Application by GT R4 Limited (trading as Outer Dowsing Offshore Wind) for an order granting development consent for the Outer Dowsing Offshore Wind Project (Generating station and transmission infrastructure)

2.0 [REP4-022](#) (Part 1 of 2) and [REP4-024](#) (Part 2 of 2)] Appendix 24.2 Flood Risk Assessment: Onshore ECC & 400kV Cables (Document Reference: 6.3.24.2, Rev: V4.0, Date: 3 February 2025)

Appendix A

**Wet and dry conditions annotated onto Figure No. 54 [\[REP4-098\]](#)
(the flood depth difference for the 0.5% AEP plus CC Breach 2
Proposed Scenario)**

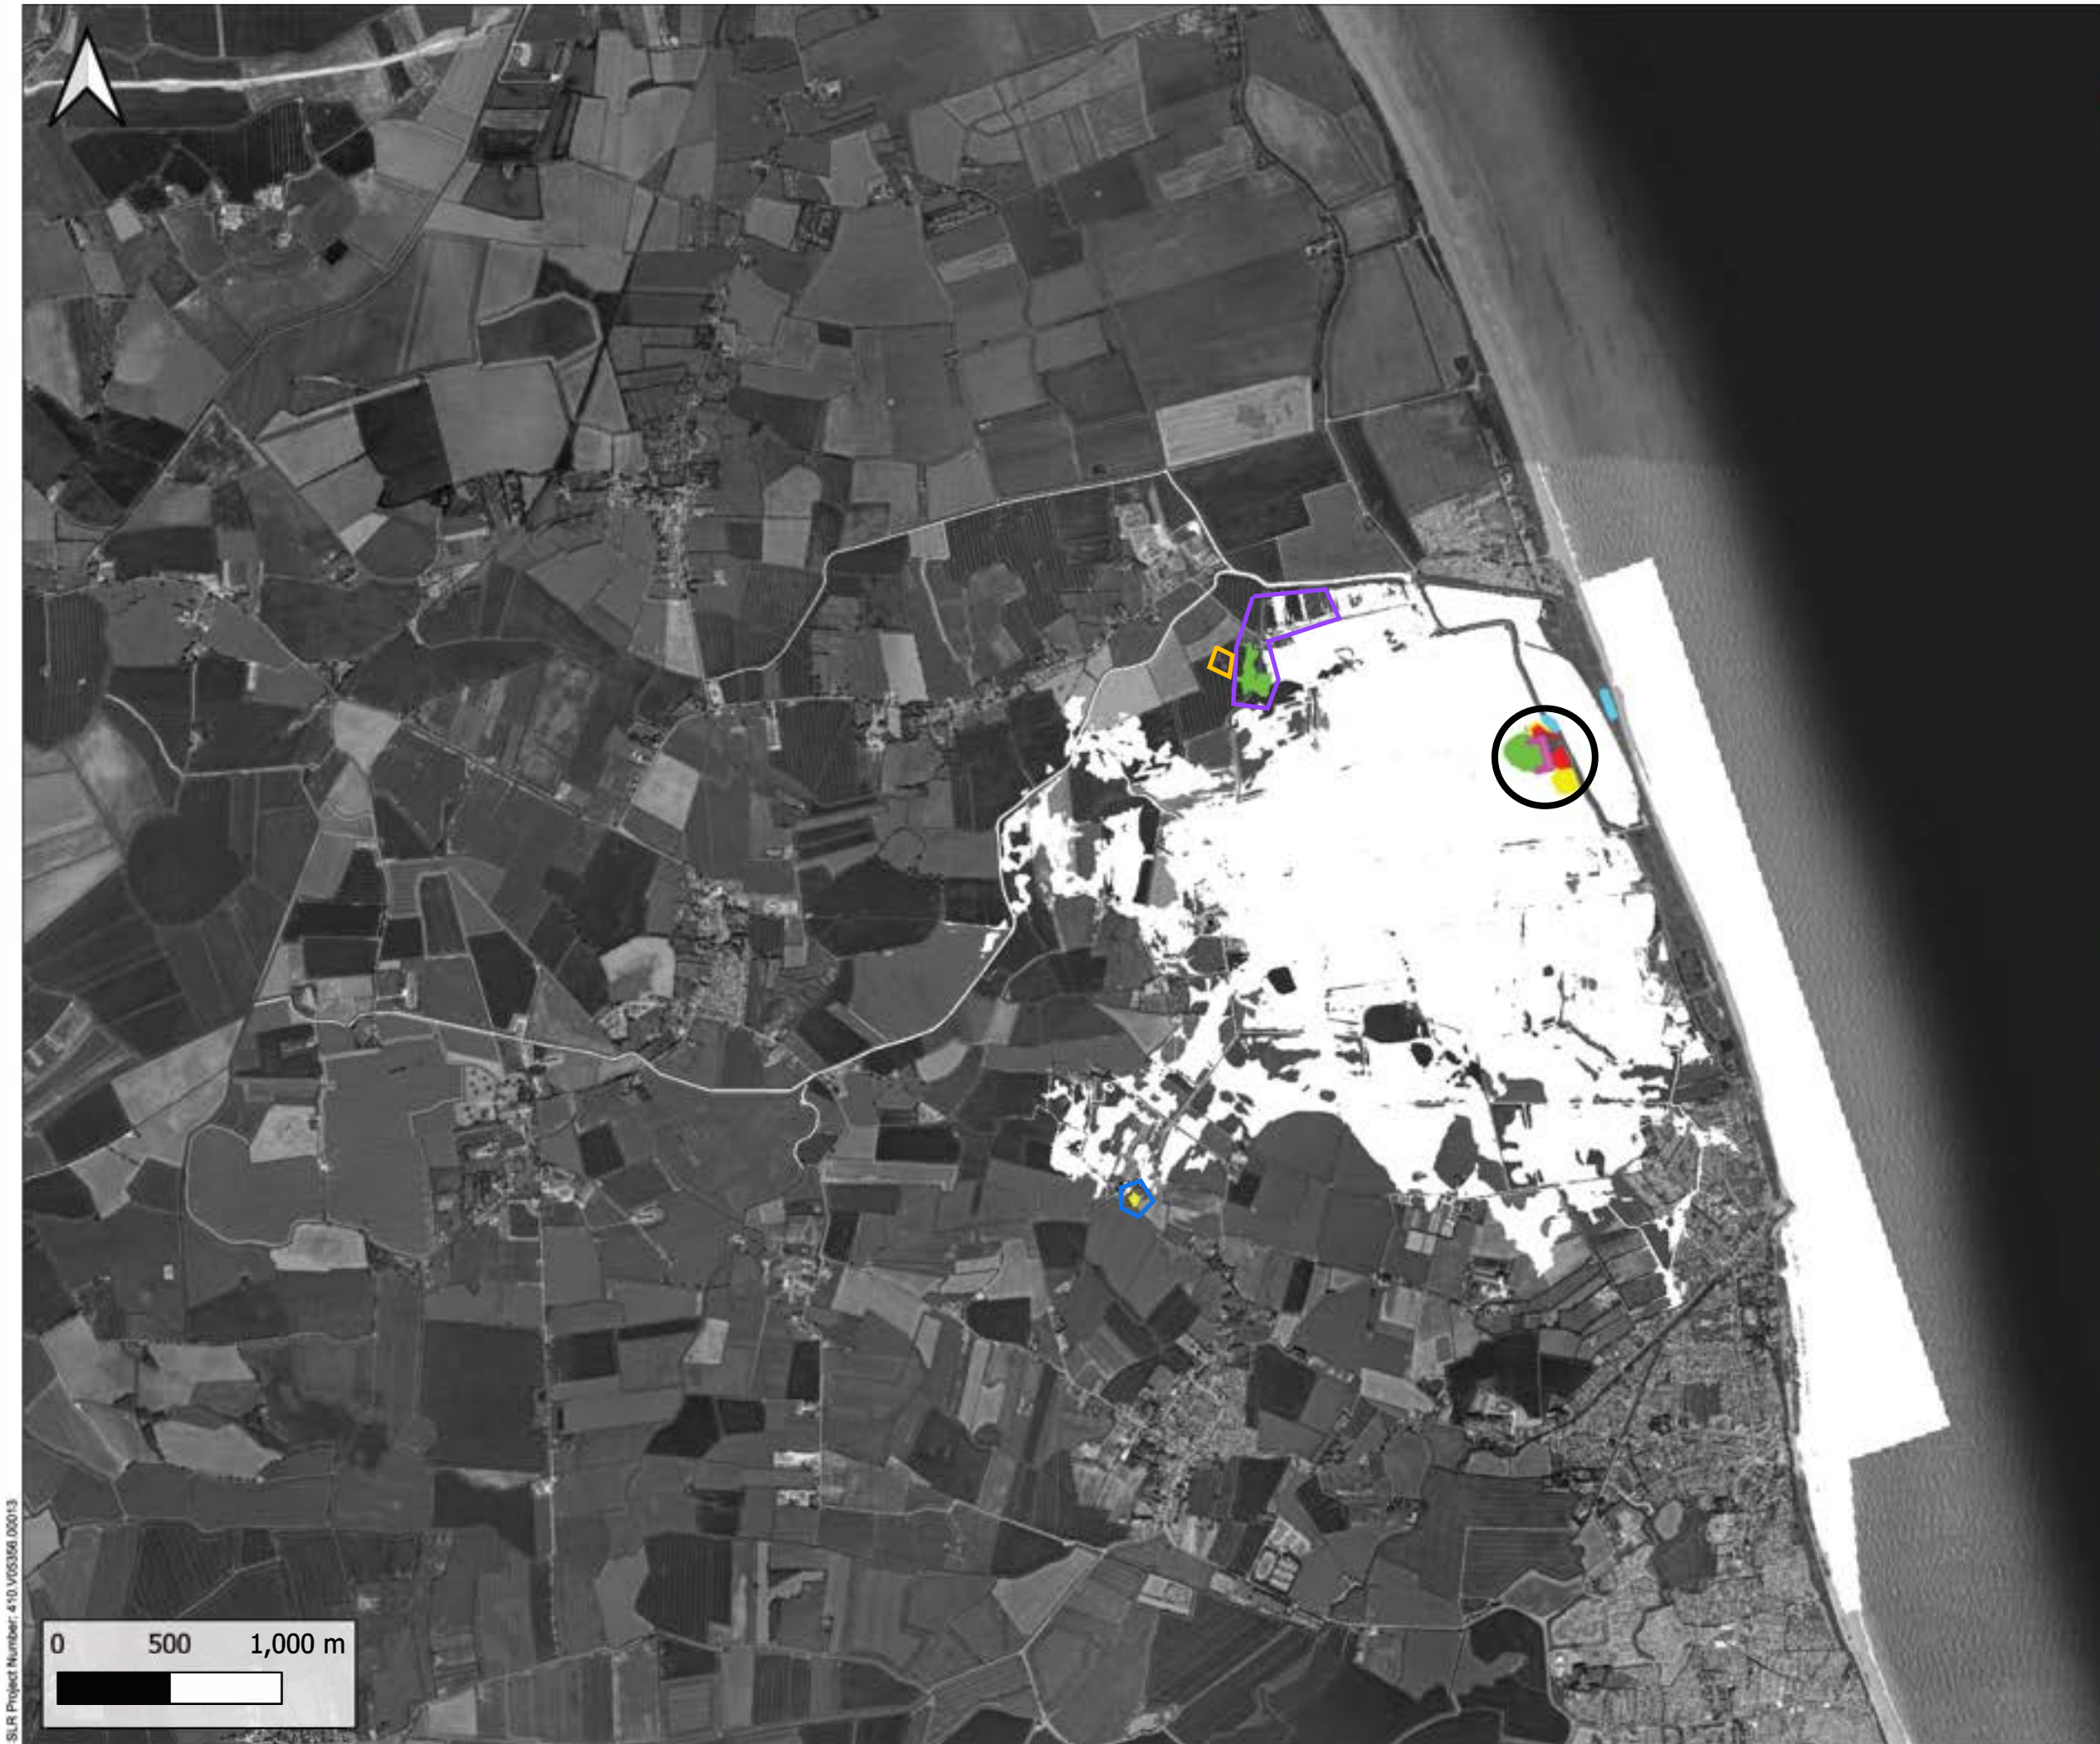
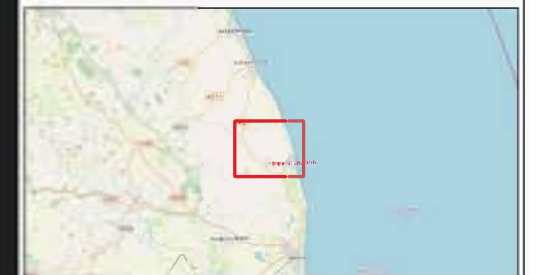
2.4 The FRA does not set out the impact of the temporary noise bund for the 0.5% ('design') event (1 in 200 chance each year) with an allowance for climate change. To assist the Examining Authority in considering the design event, we have annotated the locations where there is a change in wet and dry conditions onto Figure No. 54 [[REP4-098](#)] (the flood depth difference for the 0.5% AEP plus CC Breach 2 Proposed Scenario) and we attach this as Appendix A below. This highlights –

- Area 1 (purple outline): The modelling shows a reduction compared to the baseline flood depths.
- Area 2 (orange outline): The modelling shows areas that were previously wet and are now dry.
- Area 3 (blue outline): The modelling shows an increase of between 0.01 to 0.03m (10mm to 30mm). However, this is confined to an area of open water/pond which is likely to impact upon the modelling.
- Area 4 (black outline): The modelling shows a decrease and increase in flood depths due to the temporary noise bund.

- 2.9 To assist with your deliberations on this matter, we have highlighted the increases of up to 30mm for the 0.5% ('design') event (1 in 200 chance each year) with climate change and up to 60mm (as referenced in paragraph 123 of the FRA) for the 0.1% event (1 in 1000 chance each year) with climate change and the areas affected (resulting from the presence of the proposed temporary noise bund). However, as stated in the FRA, these increases do not appear to impact on any sensitive receptors.
